**Source:** Prestolite Leece-Neville Heavy Duty Systems  
**Bulletin No:** TSB-1233 **Date:** October 27, 2023  
**Models:** BLD3368GH, BLD3368HC, BLD3387GH, BLD3387HC  
**Subject:** Terminal identification to replace with BLD4114M

**This document is to identify terminal variances between  
Prestolite BLD3000 to Prestolite BLD4114M.**

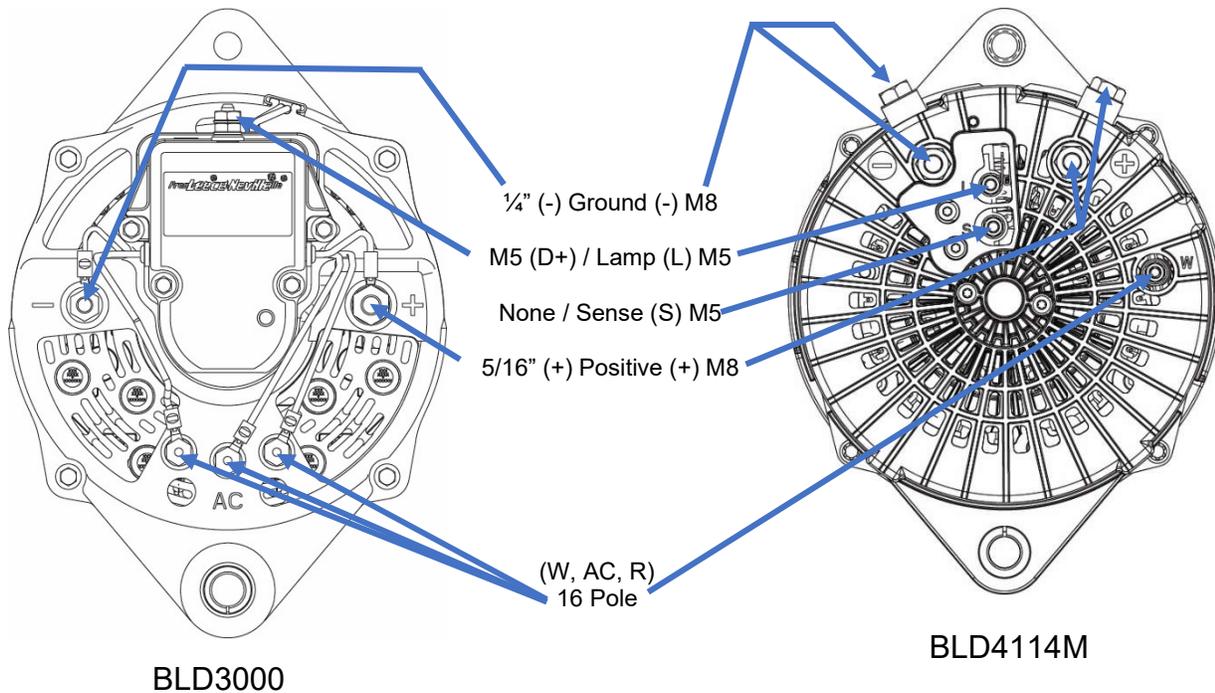
**Note:** Two positive and negative connections on BLD4114M series alternators are common connections.  
Use the connection that works best in your application.

**Single alternator applications**, connection to remote sense on BLD4114M is not required.

**Dual alternator applications**, connection to remote sense on BLD4114M is required.  
See TWB-0101 for more information.
